ENVIRONMENTAL RE-EVALUATION FORM

Project Name/Description

The FHWA and SCDOT propose to upgrade the I-20/26/126 corridor and reconstruct associated interchanges in Richland and Lexington Counties, South Carolina. The primary purpose of the proposed Carolina Crossroads project is to implement a transportation solution(s) that would improve mobility and enhance traffic operations by reducing existing traffic congestion within the I-20/26/126 corridor while accommodating future traffic needs.

Attachment B – Phase 1 Design Changes

**Figure 1 Design Modifications
Carolina Crossroads Phase 1**

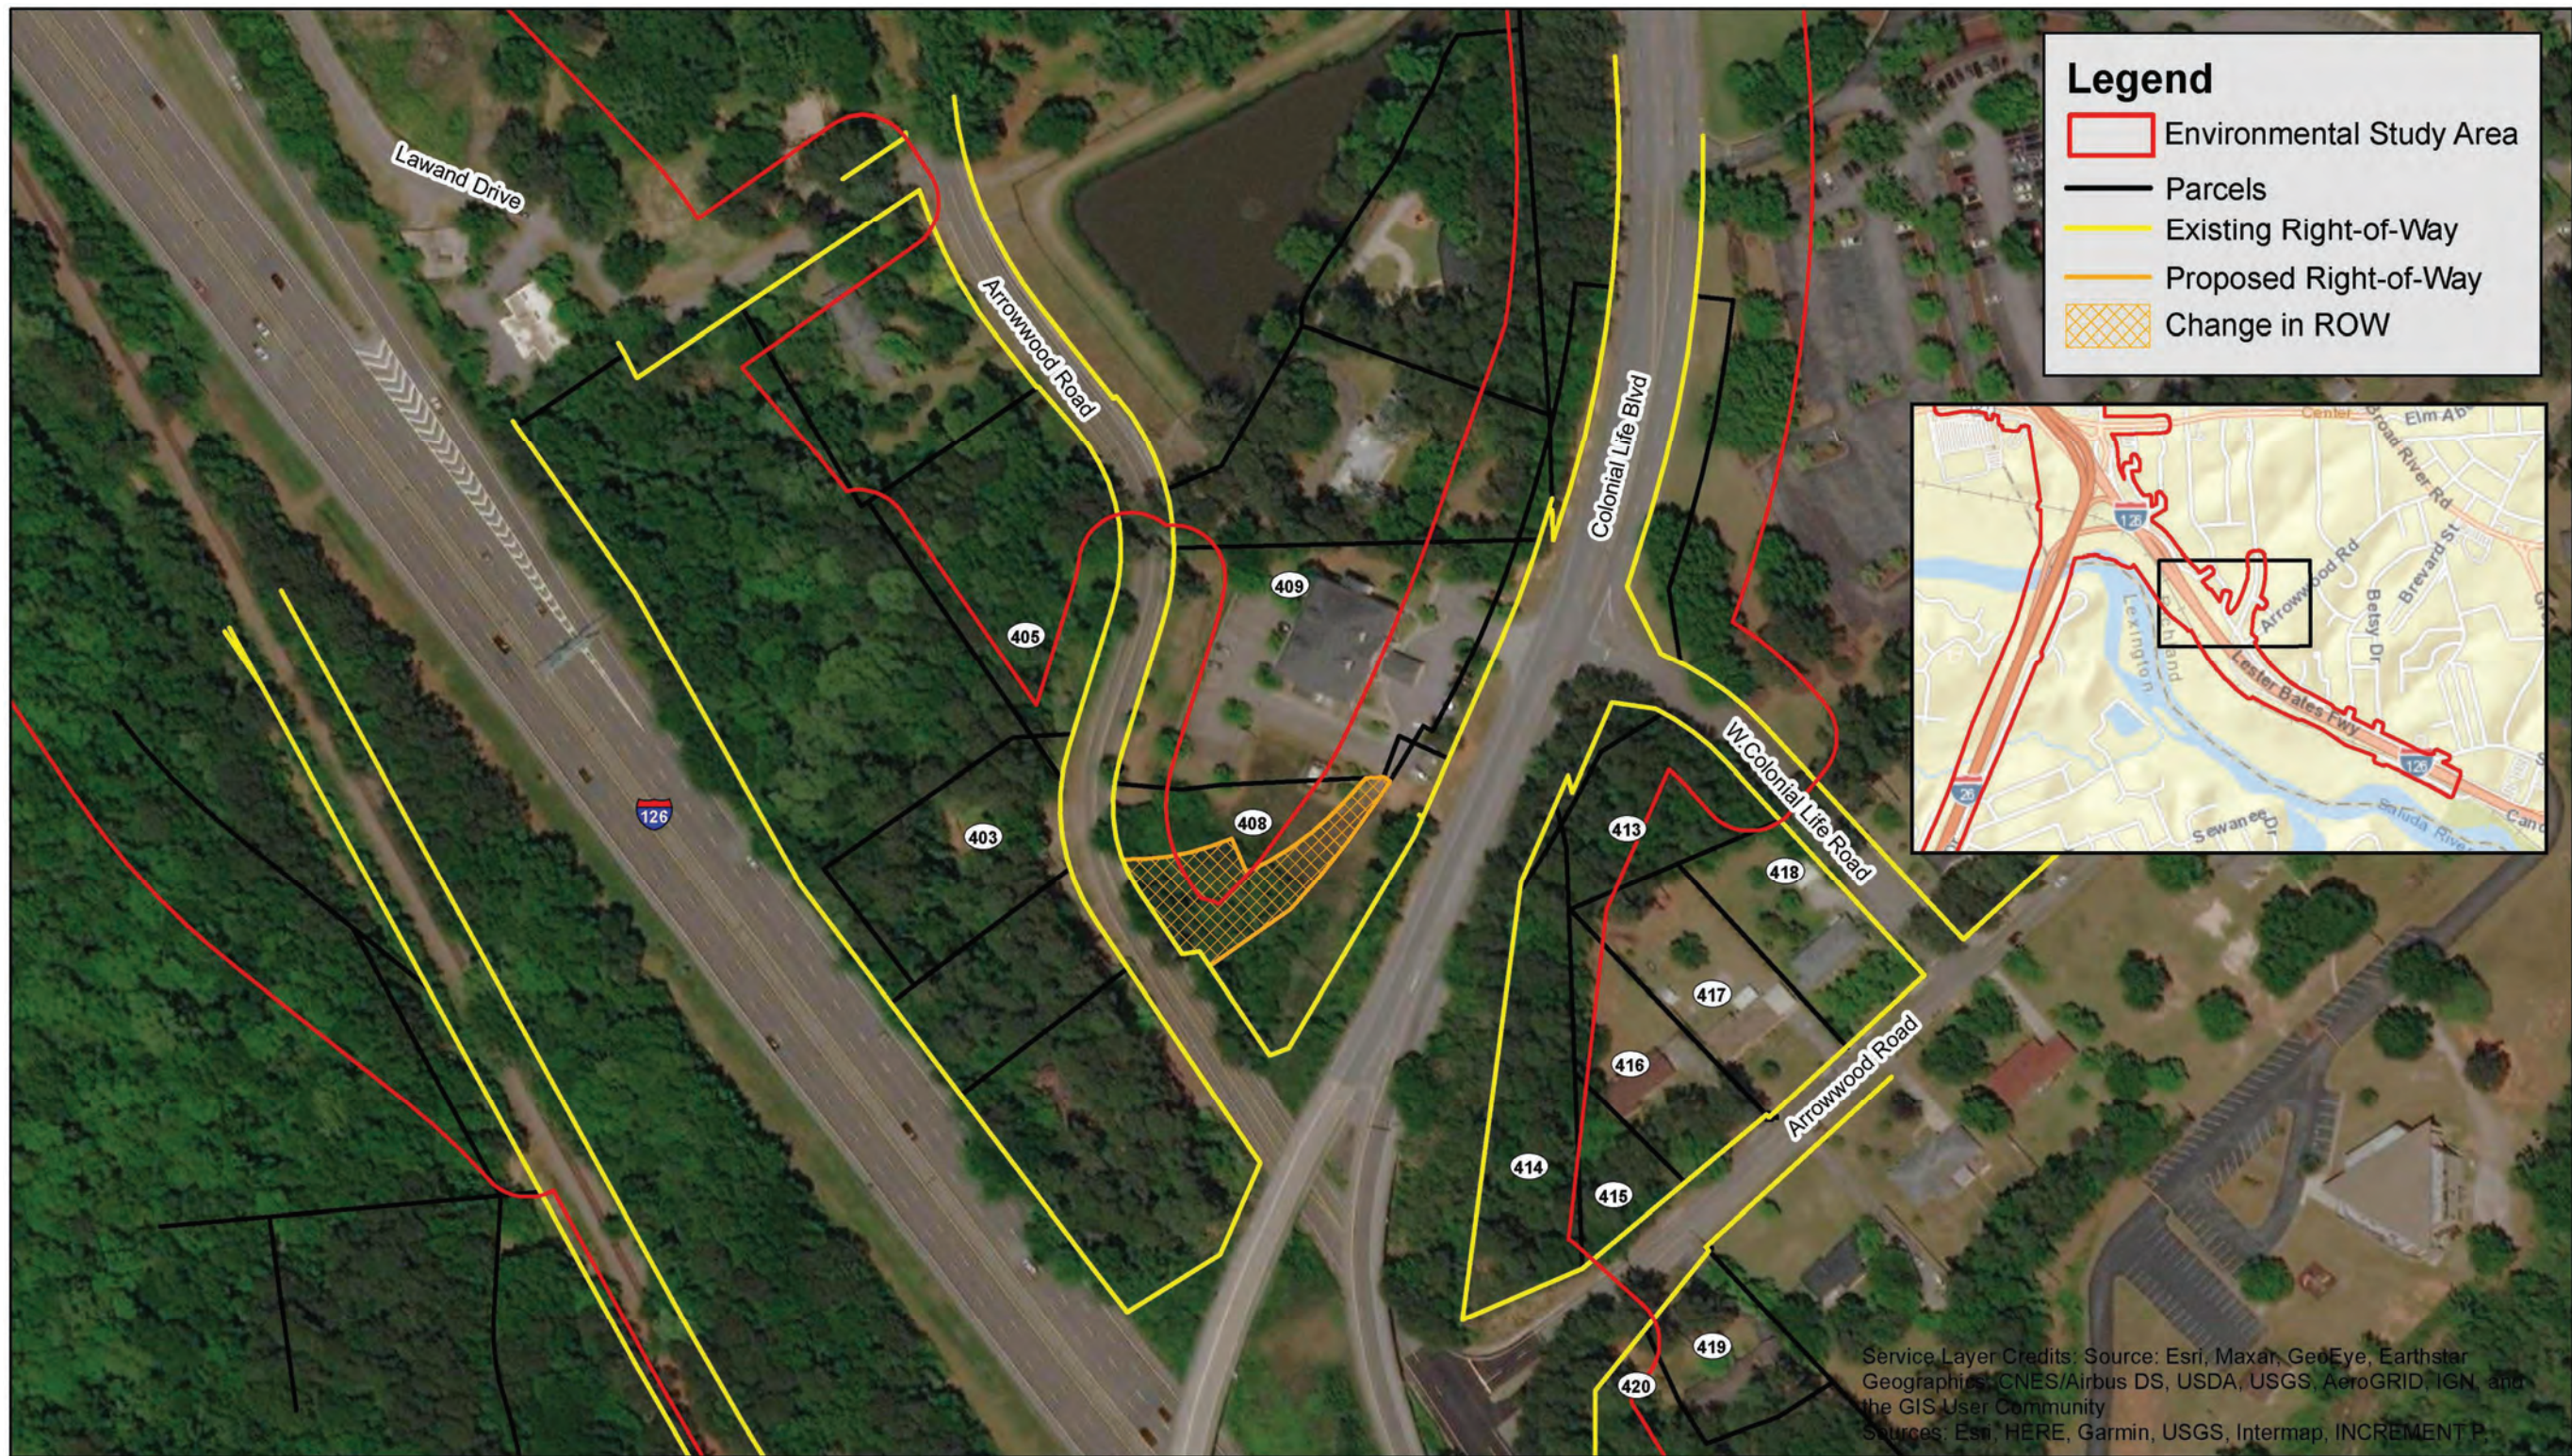
The CCR Phase 1 design-build team developed an alternative design for this interchange—a partial diverging diamond interchange (DDI). Following an extensive analysis of the alternative design, the proposed partial DDI design was chosen as the most preferred concept based on design innovation, constructability, cost effectiveness, and traffic operations (see **Figure 1** for the design changes).

CCR Phase 1 expands the existing partial interchange with direct connectors oriented towards the east to serve the traffic to and from downtown Columbia and provides direct connectors to and from the west of the interchange. The purpose of the project is to provide traffic access to and from I-26 and I-126 to Colonial Life Boulevard in all directions, allowing for permanent closure of the I-26/Bush River Road interchange. However, Colonial Life Boulevard terminates at I-126. As a result, the new design is a partial DDI with access to the interchange only from the north, east, and west. This partial DDI design creates a new single “crossover” intersection instead of two signalized intersections as proposed in the FEIS. The crossover is where three of the four interchange ramps intersect at a single location. The revised design will also maintain and rehabilitate the existing Colonial Life Boulevard ramp bridges from I-126 west and to I-126 east.

1. Modification of the system-to-system ramp from westbound I-26 to eastbound I-126. The change was made at the request of SCDOT to avoid a large Dominion Energy transmission tower. This change led to the eastbound entry ramp merge point to I-126 from the I-126/Colonial Life Boulevard interchange being moved closer to the Greystone Boulevard interchange.

2. Modification of the right-turn movement from the westbound I-126 exit ramp to northbound Colonial Life Boulevard. The free one-lane right-turn movement was modified to a two-lane signal-controlled movement.

3. Modification of the intersection of Colonial Life Boulevard and West Colonial Life Boulevard from a right-in/right-out into a full intersection. This intersection will include a signal that will work in tandem with the signal at the new crossover intersection. It was determined that the Colonial Life Boulevard/West Colonial Life Boulevard intersection and the new crossover intersection could essentially be clustered and operated with a single controller due to their proximity to each other.

Figure 2 Right-of-Way Impact Change

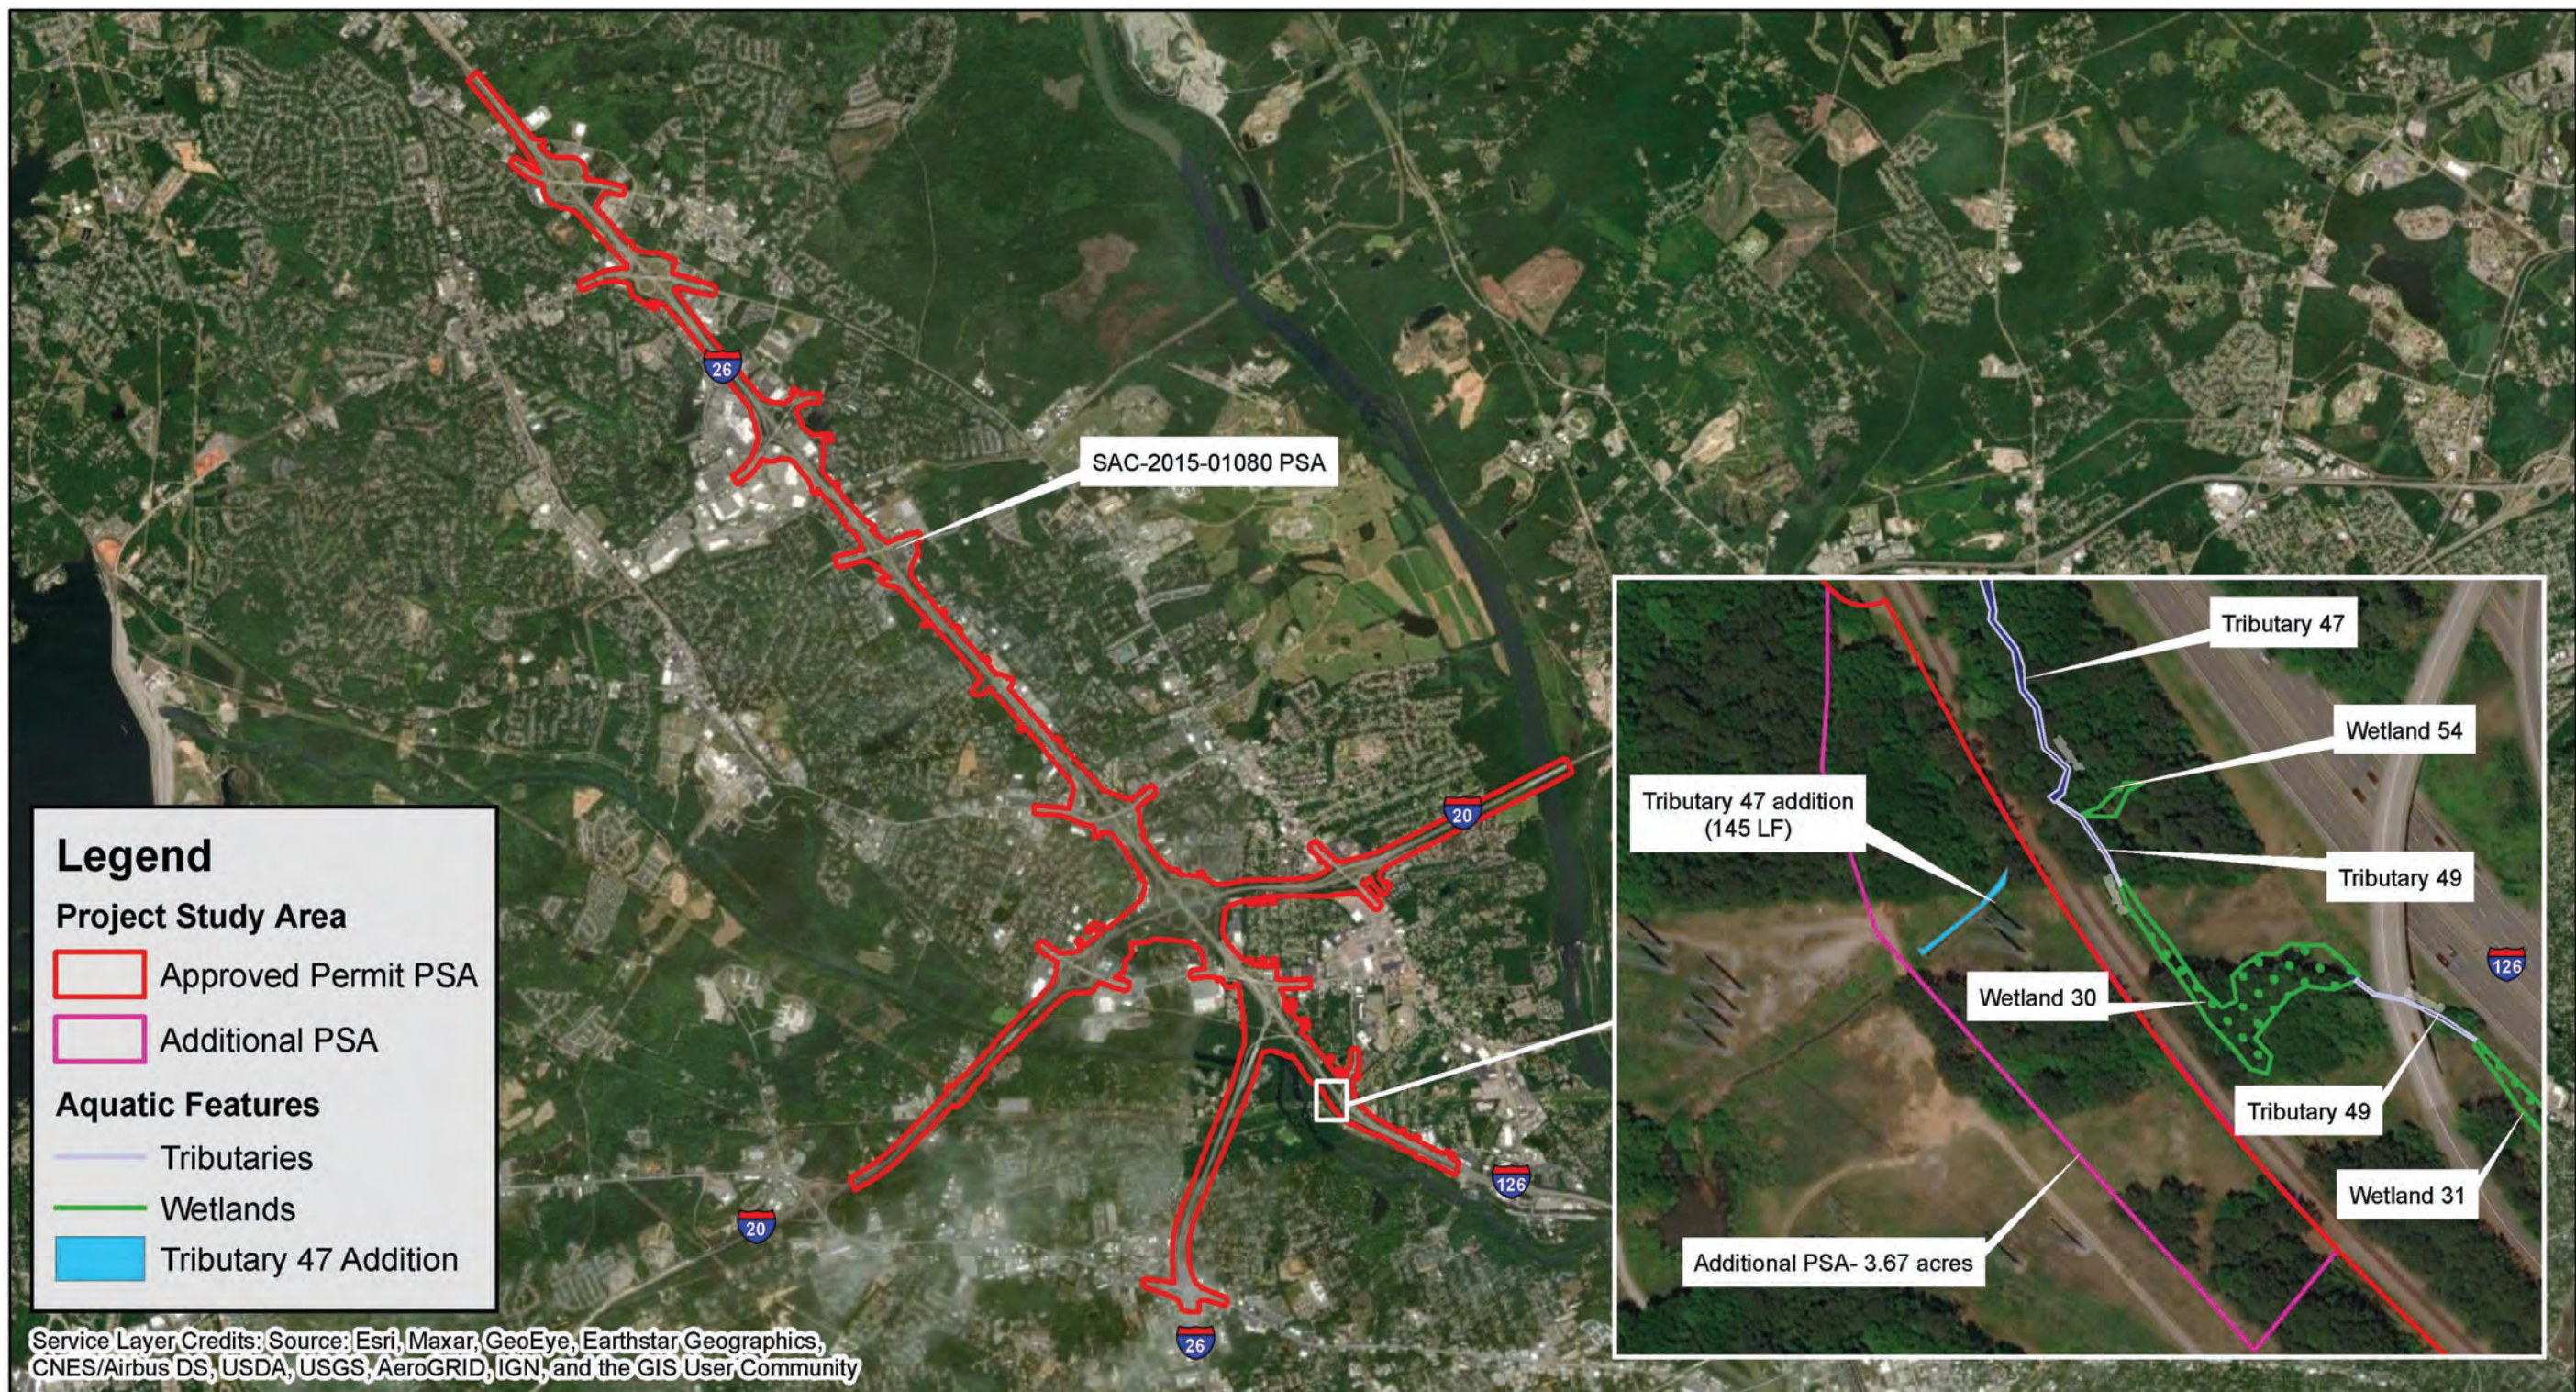
The design revisions result in changes to the amount of right-of-way to be acquired. Approximately 0.35 acre of additional right-of-way is needed for CCR Phase 1, compared to the previous RRPA design. Additional right-of-way will need to be acquired from one parcel (Parcel 408) by the new interchange at I-126 and Colonial Life Boulevard, as shown in **Figure 2**. A small portion (approximately 0.06 acre) of the additional right-of-way on Parcel 408 extends beyond the previously surveyed project study area (PSA) for the FEIS/ROD (environmental study area). This area was field reviewed for jurisdictional features (streams, wetlands), cultural resources, and hazardous waste sites/hazardous materials. The area assessed is an undeveloped forested upland area and is part of a larger parcel that is commercially developed to the north. Based on the field review, and review of previous studies, no environmental constraints were identified, and no new environmental impacts are anticipated.
